South Texas Project Electric Generating Station P.O. Box 289 Wadsworth, Texas 77483

June 17, 2010
U7-C-STP-NRC-100146

South Texas Project
Units 3 and 4
Docket Nos. 52-012 and 52-013
Response to Request for Additional Information

RAI 06.04-3

Berm Geometry

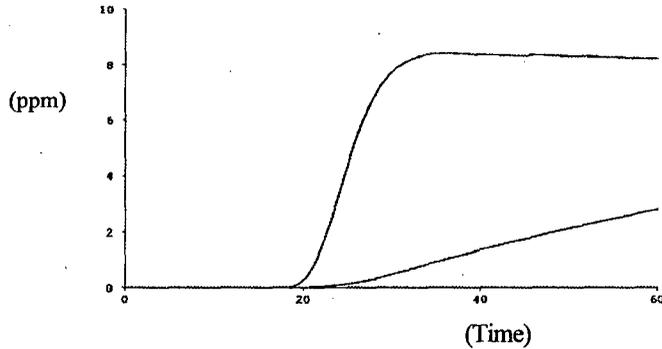
- Justify the maximum puddle size of 100 m radius (31,400 m² area) for Acetic Acid (Offsite Storage) assumed by ALOHA, as no berm geometry or natural topography details are provided that would constrain the puddle size to within a 100 m radius. The staff's confirmatory calculations using HABIT demonstrate that if not confined, the Acetic Acid could spill far beyond 100 m radius and, consequently, lead to a concentration level inside the control room significantly exceeding the IDLH.

Acetic Acid is stored at the OXEA Bay City Plant. Based on information received from the OXEA Bay City Plant, the immediate containment area around this tank has a surface area of 5,422 ft² in area—any larger spills would overflow to a concrete lined channel spillway with a surface area of 3,700 ft². This spillway safely directs the flow to an Emergency Containment Area (ECA) which is a large surface impoundment area with a surface area of 97,782 ft².

- Immediate containment area: 5,422 ft² surface area—which is only a few inches deep, assuming a 2 inch depth, yields a volume of approximately 903 ft³.
- Spillway: 3,700 ft² surface area—10 feet wide, 3 feet deep, and 370 feet in length, yielding a volume of 11,100 ft³.
- Emergency Containment area: 97,782 ft² surface area—6 feet deep, yielding a volume of 586,692 ft³.

Accordingly, when accounting for the total surface area of the containment area for the Acetic Acid tank (i.e., 106,904 ft² or approximately 9,932 m²)—that yields a radius of 56.3 m. This is much less than the 100 m radius (31,400 m² surface area) used as a maximum puddle size in the ALOHA analysis and considered a realistic value for modeling purposes.

Acetic Acid (Offsite Storage) Sixty Minute Concentration Curve—IDLH 50 ppm

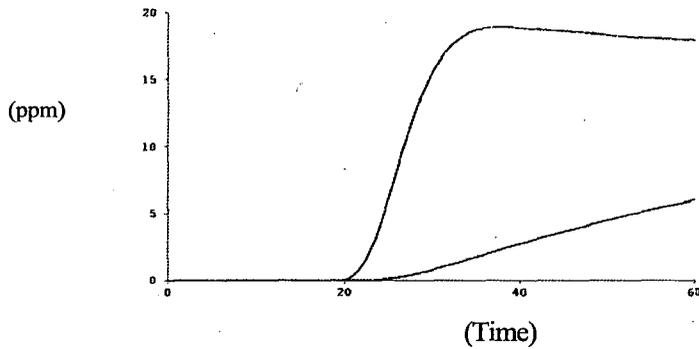
- All toxic gas analysis runs using ALOHA automatically stop at 1hr, while some results show that the control room inside and outside concentrations are still increasing. Complimentary HABIT runs have shown that some control room concentrations can exceed IDLH past the first hour. Demonstrate or justify that the 1-hr analysis cut-off is conservative enough to meet the NRC rules and regulations.

In the five scenarios identified in RAI 06.04-2, in every case the concentration outside the control room was well below the IDLH or identified toxicity limit at the end of the 60-minute run-time in ALOHA and, in all but one case, Sodium Hypochlorite (Onsite Storage), the outdoor concentration had also begun to decline. Even though the inside concentrations are still increasing they would not

become higher than the outside concentrations. This is demonstrated in the ALOHA concentration curves provided below for each of the identified scenarios: Acetic Acid (Offsite Storage), Acetic Acid (Water Transport), Gasoline (Water Transport), 1-Hexene (Offsite Storage), and Sodium Hypochlorite (Onsite Storage).
